RFI VA246-13-B-0628 B7 Project

DRAWING A QUESTION 6

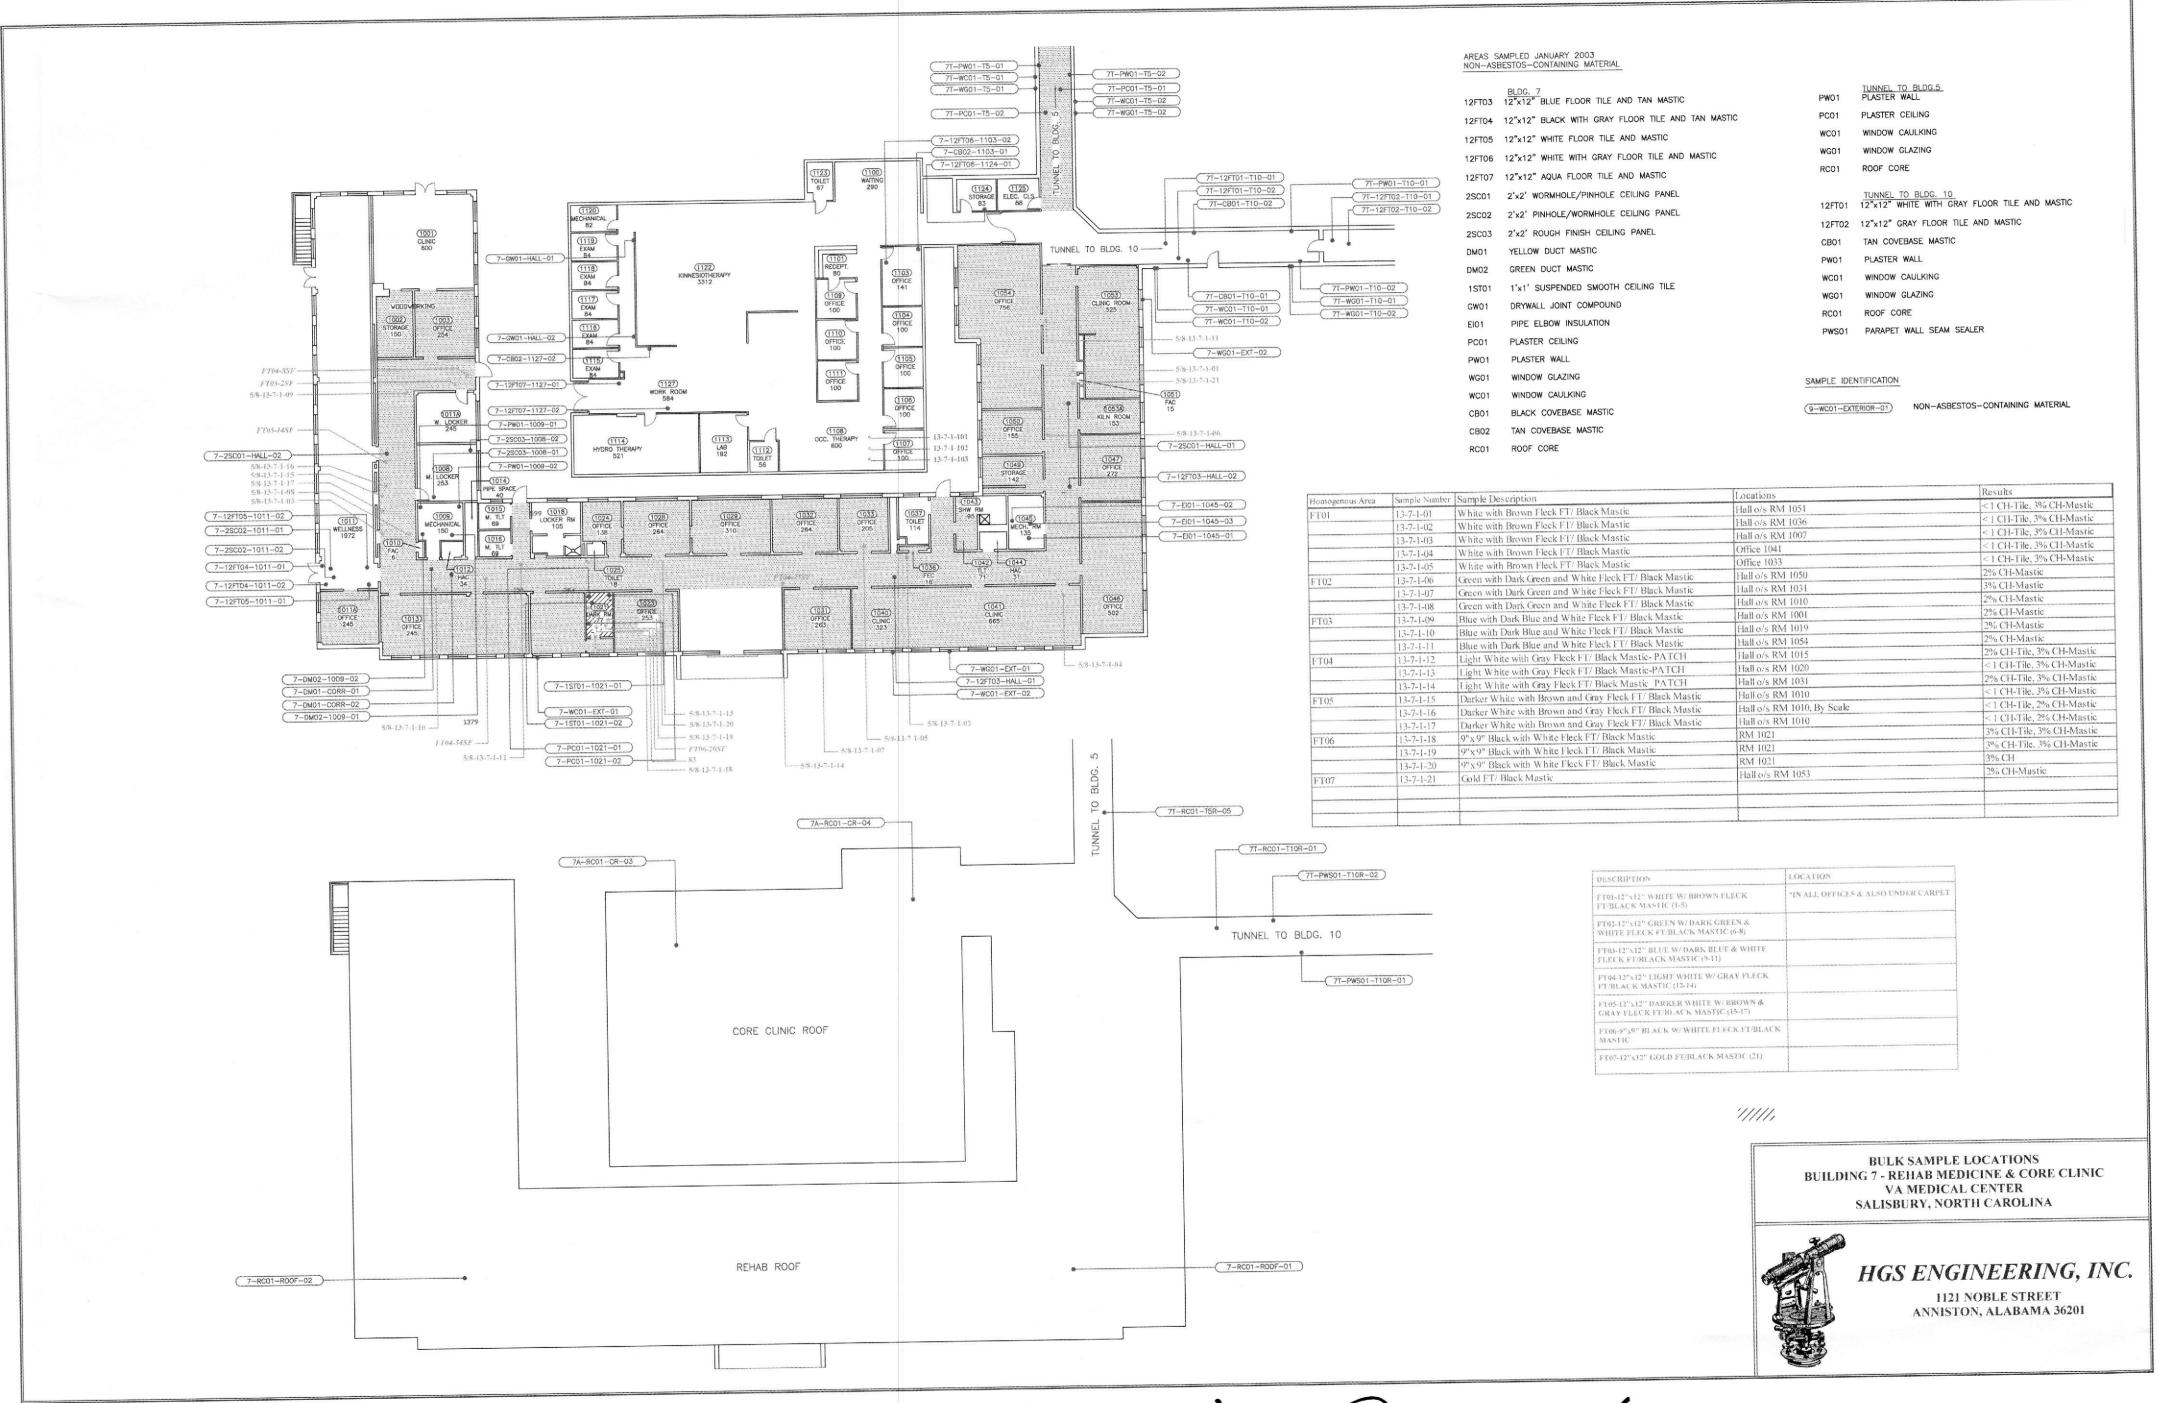
6. Room 1011 shows that it is to have new flooring installed. Has this area been tested for asbestos and if so, is there a report for this area?

There is no asbestos mastic in the room 1011. See attached drawing. "A"
